LOT 9

LOT 7

SHEET 2 FOR
PLANS LIST

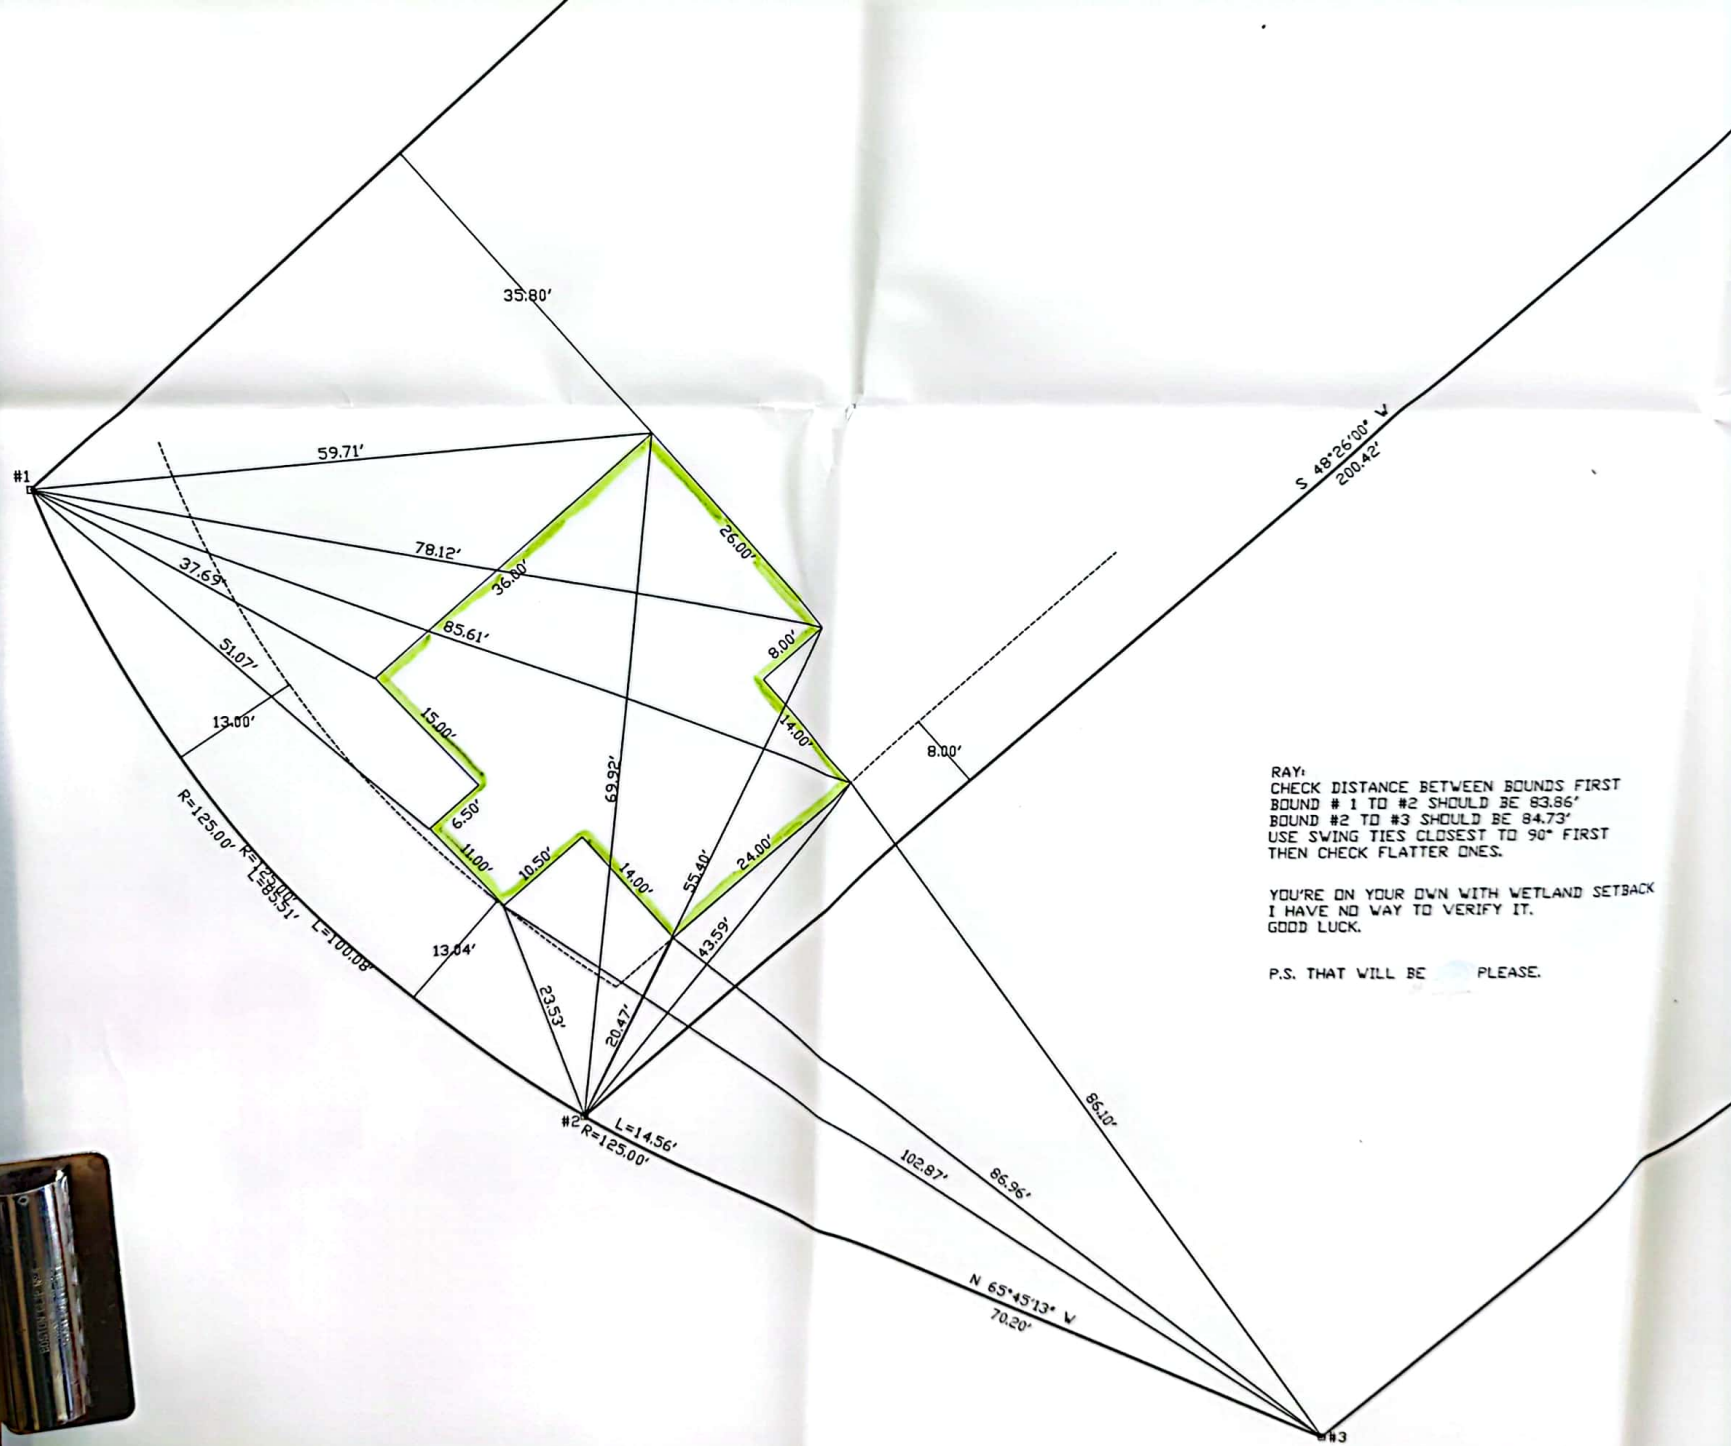
CHECK #4 TO #5
SHOULD BE 76.16'

CHECK #5 TO #6
SHOULD BE 75.03'

RAY:
CHECK DISTANCE BETWEEN BOUNDS FIRST
BOUND #1 TO #2 SHOULD BE 83.86'
BOUND #2 TO #3 SHOULD BE 84.73'
USE SWING TIES CLOSEST TO 90° FIRST
THEN CHECK FLATTER ONES.

YOU'RE ON YOUR OWN WITH WETLAND SETBACK
I HAVE NO WAY TO VERIFY IT.
GOOD LUCK.

RAY:
CHECK DISTANCE BETWEEN BOUNDS FIRST
BOUND # 1 TO #2 SHOULD BE 83.86'
BOUND #2 TO #3 SHOULD BE 84.73'
USE SWING TIES CLOSEST TO 90° FIRST
THEN CHECK FLATTER ONES.

YOU'RE ON YOUR OWN WITH WETLAND SETBACK
I HAVE NO WAY TO VERIFY IT.
GOOD LUCK.
